**Errata to**
*Fundamentals of Thermodynamics* **(SDL),**
**I-P Edition (2004)**

**February 27, 2017**

*Shaded items have been added since the previously published errata sheet dated May 6, 2014.*

**Figure 7-4. Piston-Cylinder Arrangement and *p-v***

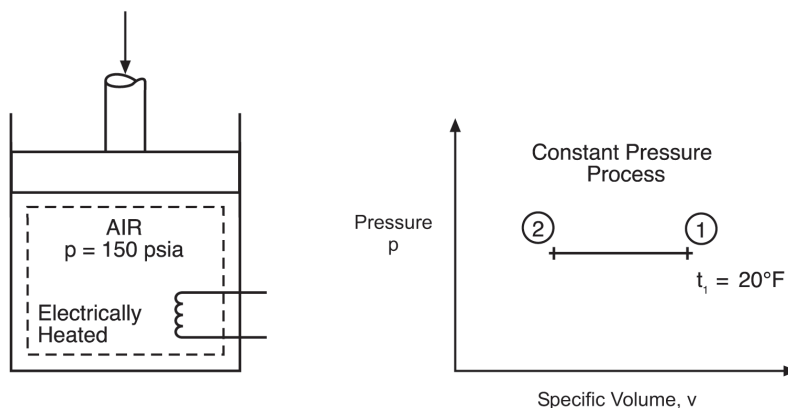
**Page 7:11**   Figure 7-4 does not show the piston. The corrected graphic follows.

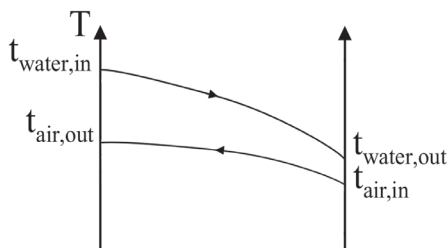
**Page 9:8**   The text beneath Table 9-2 reads:

Throttling is a constant enthalpy device, therefore:

$$t_4 = t_3 + \dot{m}_{R-22}(h_2 - h_1)/\dot{m}_{air} \cdot c_p$$
$$= 72 + 0.02(120 - 39.502)/[(0.2)(0.24)]$$
$$= 105.54°F$$

But should read "Throttling is a constant enthalpy device, therefore: $h_2 = h_1$."
